ANDALEX RESOURCES, INC.  
CENTENNIAL PROJECT

CHANGE TO ALLOW

UTILIZATION OF SEDIMENT POND A  
FOR STORAGE OF CRANDALL MINE  
IRON SLUDGE MATERIAL

**(APPENDIX XX-AA)**

## AS-BUILT DRAWING SEDIMENT POND 'A'

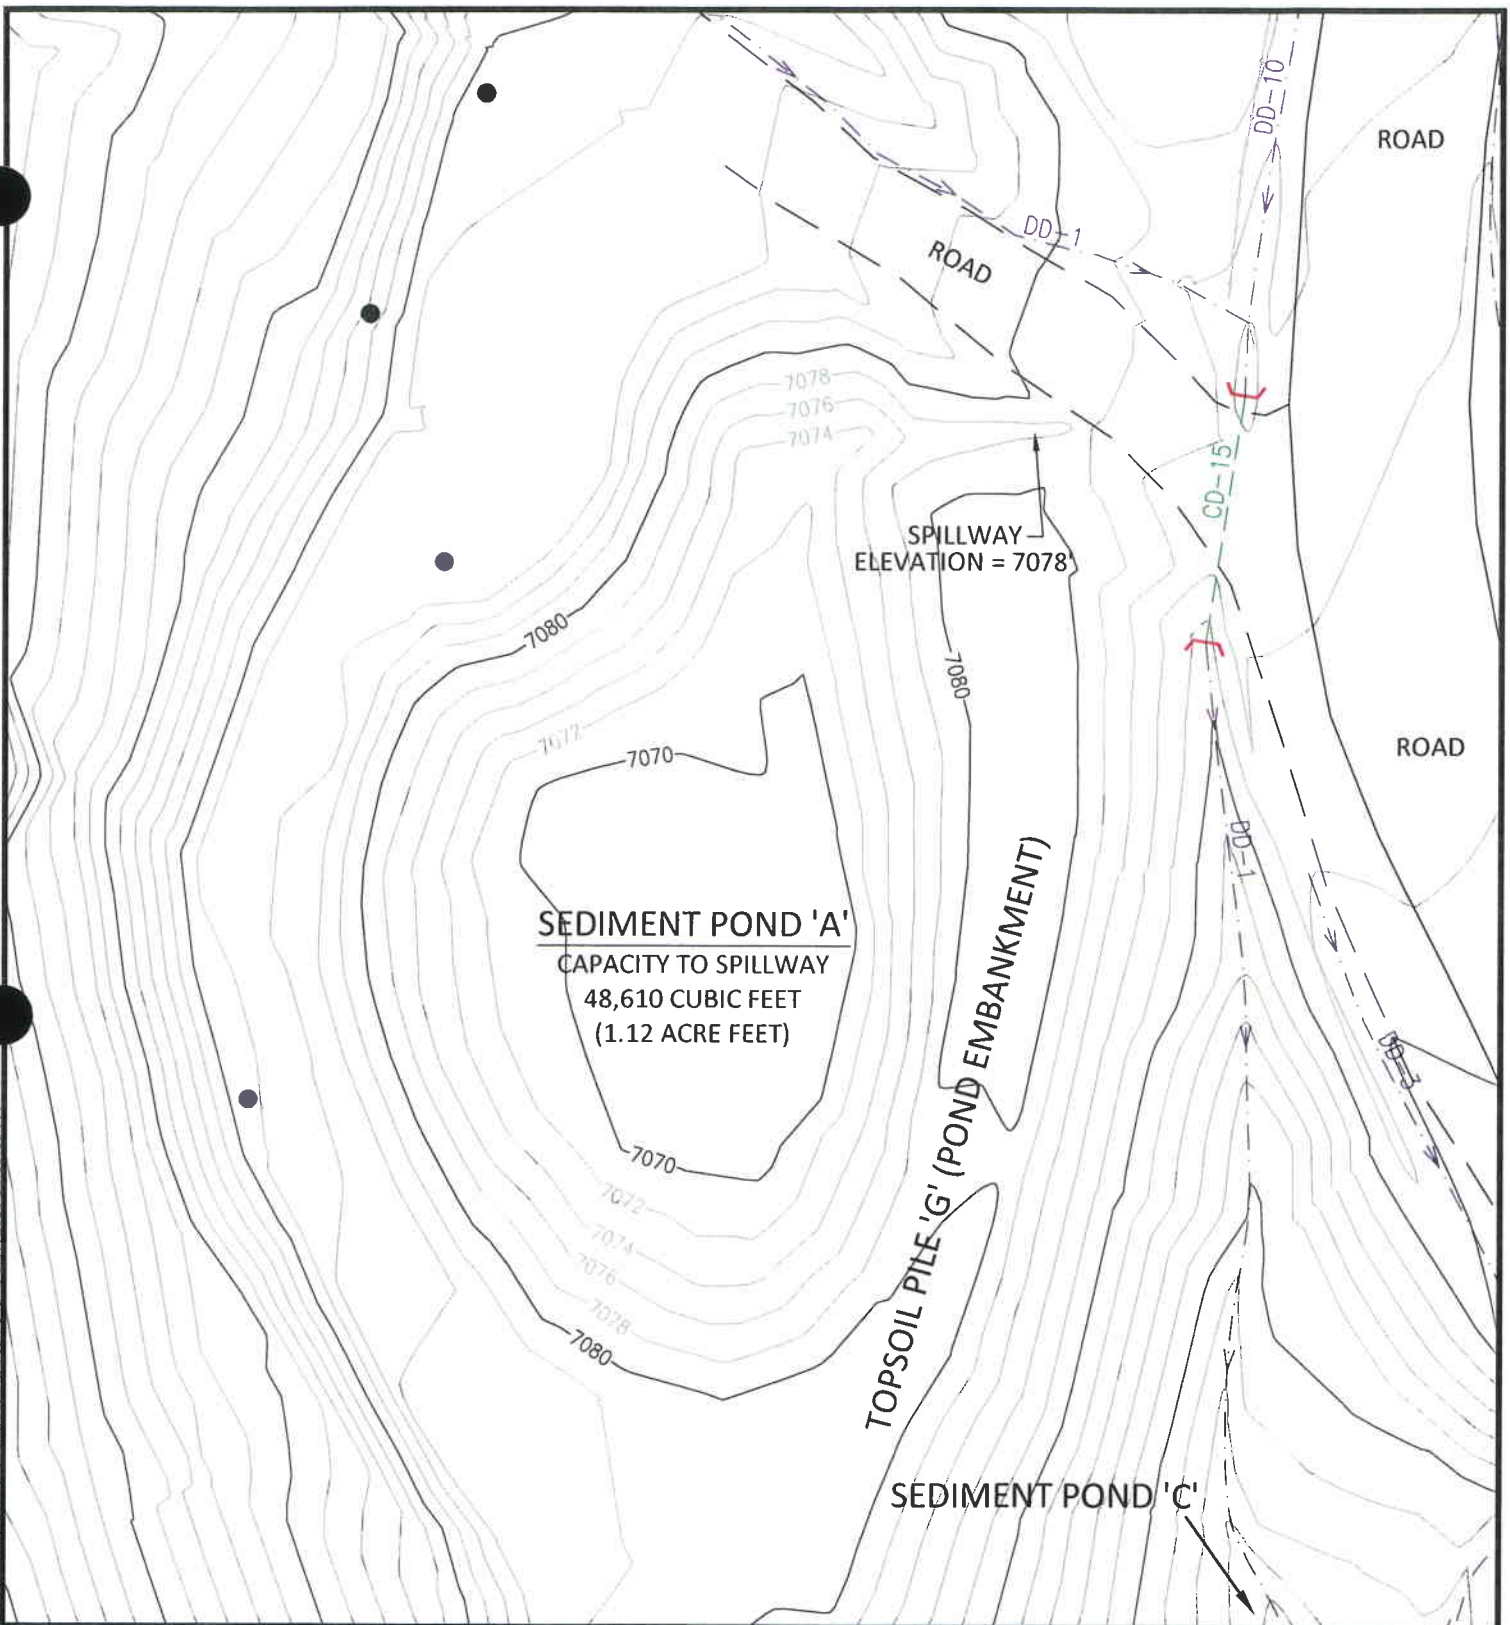
As shown in the Attachment 3 drawing in this Appendix, the storage capacity of Tower Pond A is 48,610 cubic feet or 1.12 acre-feet, available for Crandall sludge storage. Based on the limited experience of iron sludge disposal to date it is difficult at this time to estimate the actual volume of future sludge disposal needed on an on-going basis. However, based on previous experience, the sludge dries out quickly to a concentrated residual cake with minimal volume. This cake dried out in a layer about 1" thick, covering an area of about 800 sq. ft. of the bottom of Wildcat Pond C, for a total volume of approximately 66 cubic ft. This material was initially generated at the Crandall treatment facility over a three month period and involved cleaning about half the sludge from the pond. Therefore, the 66 cu. ft of dried sludge represents approximately one and a half months worth of treatment. One years worth of treatment would generate about 528 cu ft or 19.5 cu yards of dried material. Therefore, the Tower pond A, with
